The Arcade and 18-20 Corporation Street and 17 Foundry Street, Dewsbury

Summary of Amendments

Doc No. 1705-BDP-AD-XX-RG-Z-00005
Revision: P01
Date: 18 June 2026

PROJECT TITLE Dewsbury Arcade	
REF. OR NUMBER P3001705	SCALE @ A1
DRAWING TITLE Elevations as Proposed	DATE FIRST ISSUED 07/01/22
DRAWING NO. 1705-BDP-18-ZZ-EL-A-00002-	REVISION P05

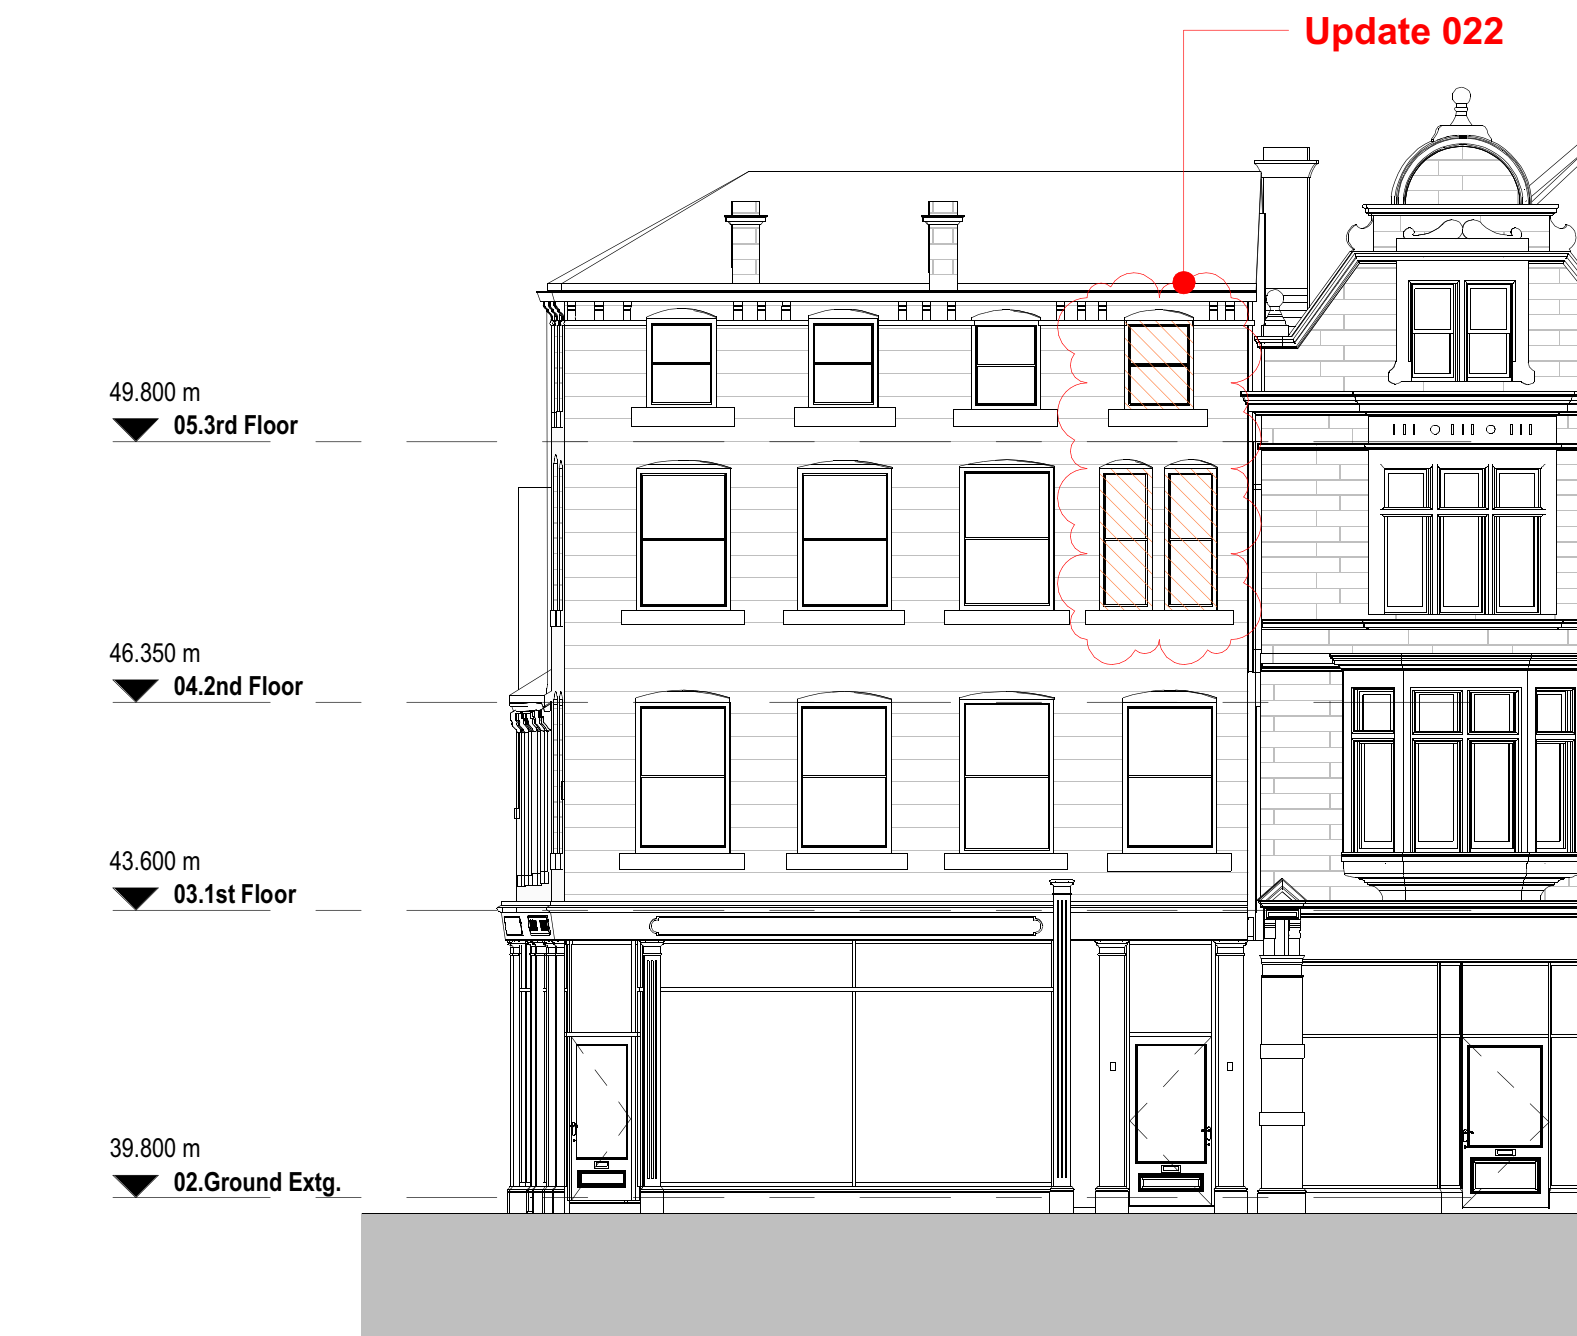
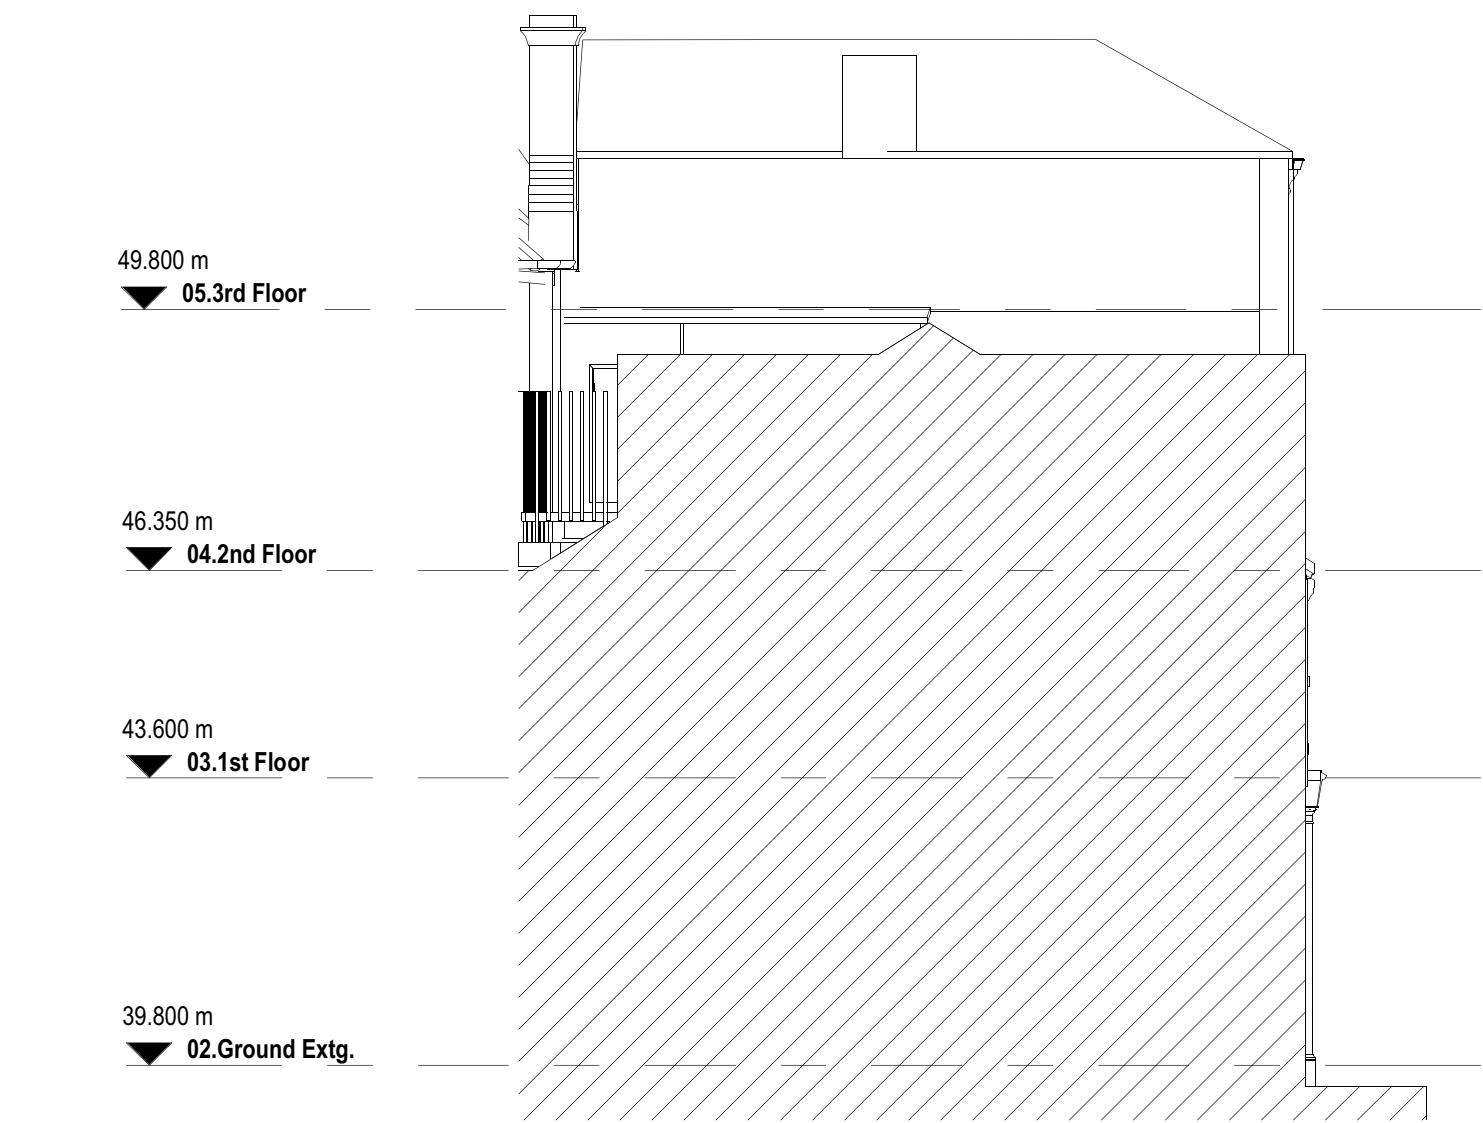
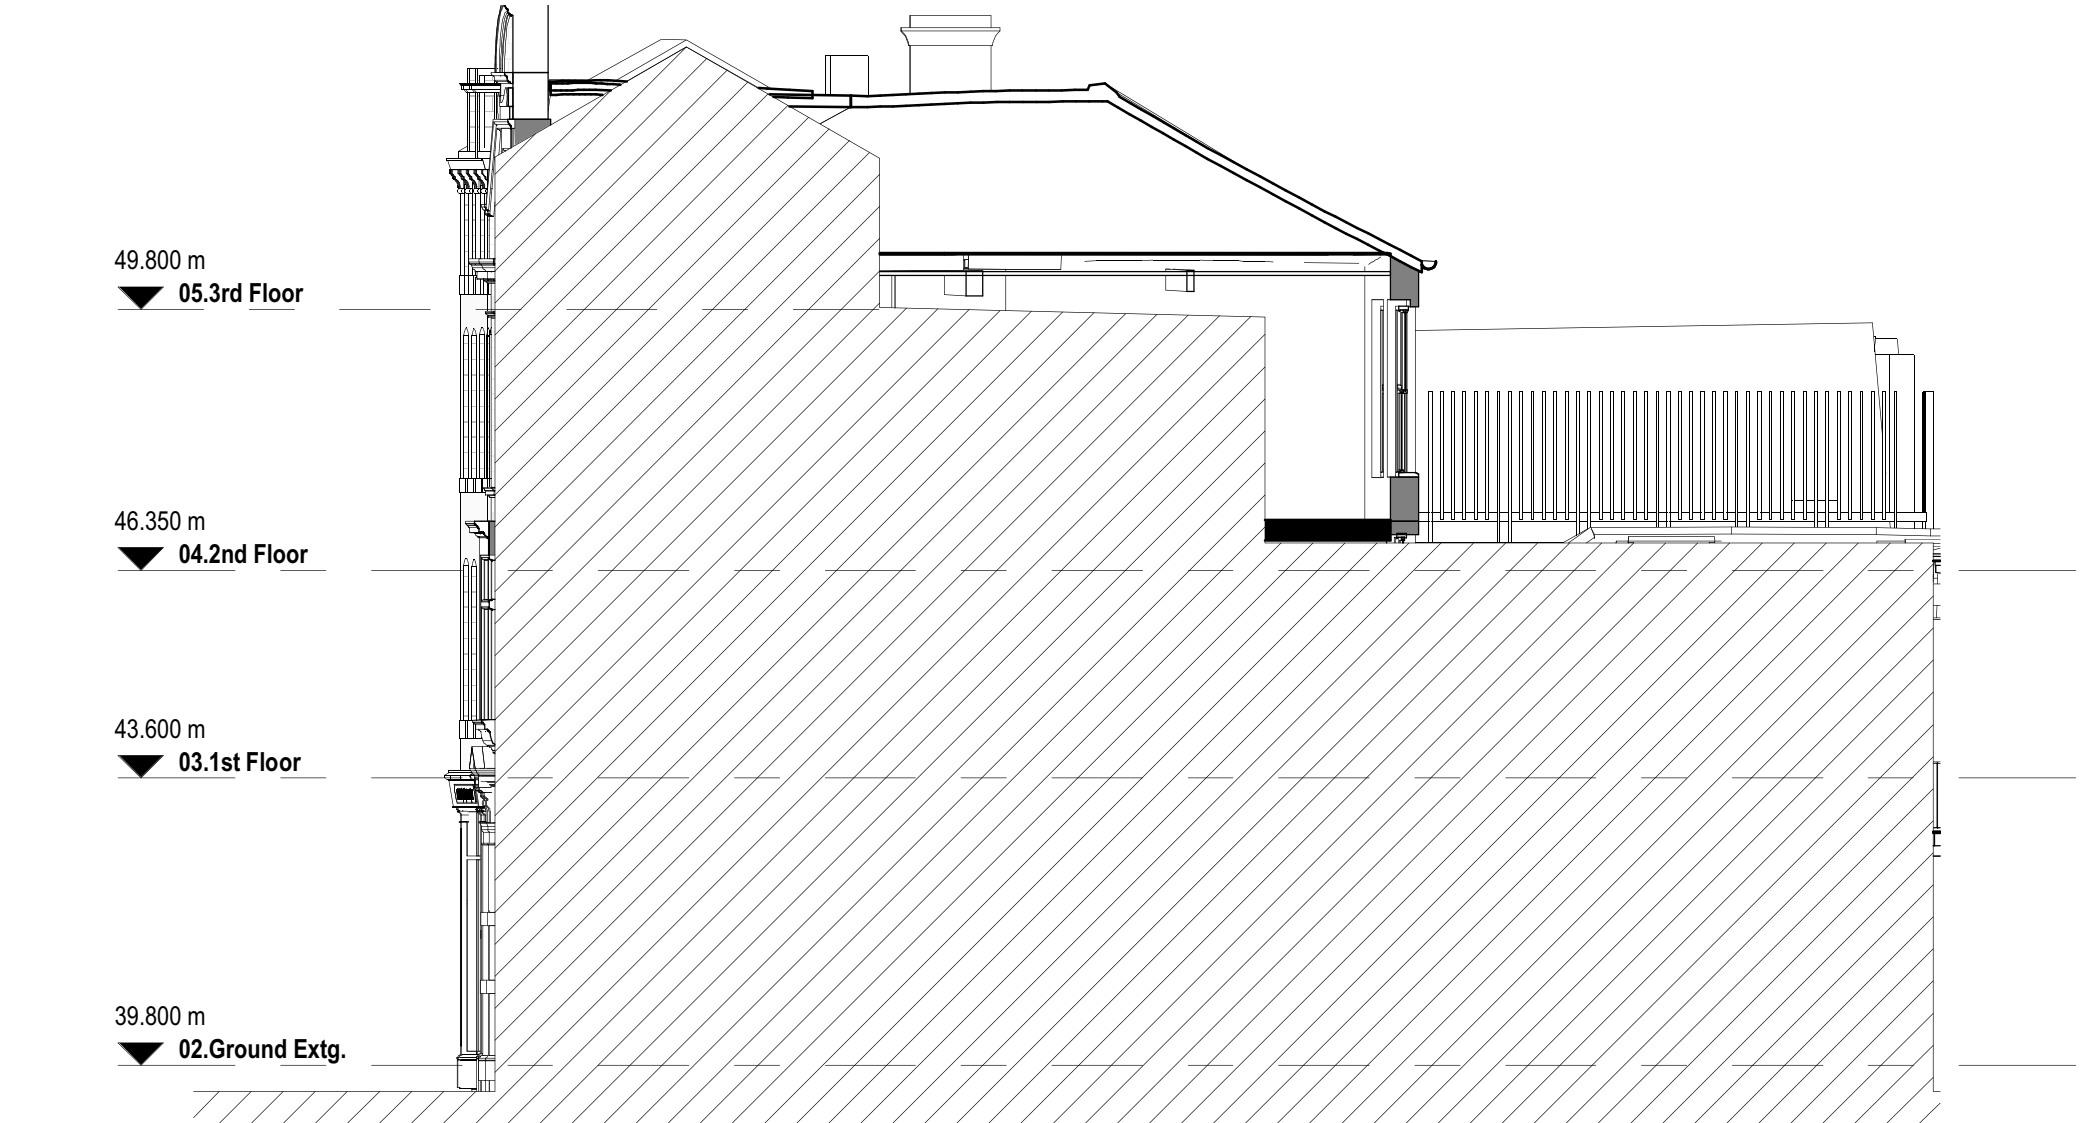
022	Central Arcade, 14-16 Corporation Street and 18-20 Corporation Street Refer to elevation drawings	Windows	Repair windows where possible using traditional techniques. Some windows were known to have extensive wet or dry rot, or were absent and were therefore proposed to be replaced.	Additional windows were found to have extensive wet and dry rot. (2 to 14-16 Corporation Street North Elevation, 2 to Central Arcade East Elevation, and 2 to Central Arcade West Elevation, 3 to 18-20 Corporation Street North Elevation)	These additional windows are so extensively decayed that they are unsuitable for repair.	Replace 6 no. windows, in addition to the 3 no. already proposed to be replaced (in unit 30, shown on Section AA). Replacement windows to match existing in size, proportions and timber profiles.	1705-BDP-AD-XX-EL-A-20001_P01 1705-BDP-AD-XX-EL-A-20005_T01 1705-BDP-AD-XX-EL-A-20004_P01 1705-BDP-AD-XX-SE-A-20002_P01 1705-BDP-18-ZZ-EL-A-00002_P04	1705-BDP-AD-XX-EL-A-20001_T02 1705-BDP-AD-XX-EL-A-20003_T02 1705-BDP-AD-XX-EL-A-20004_T02 1705-BDP-AD-XX-SE-A-20002_T02 1705-BDP-18-ZZ-EL-A-00002_P05
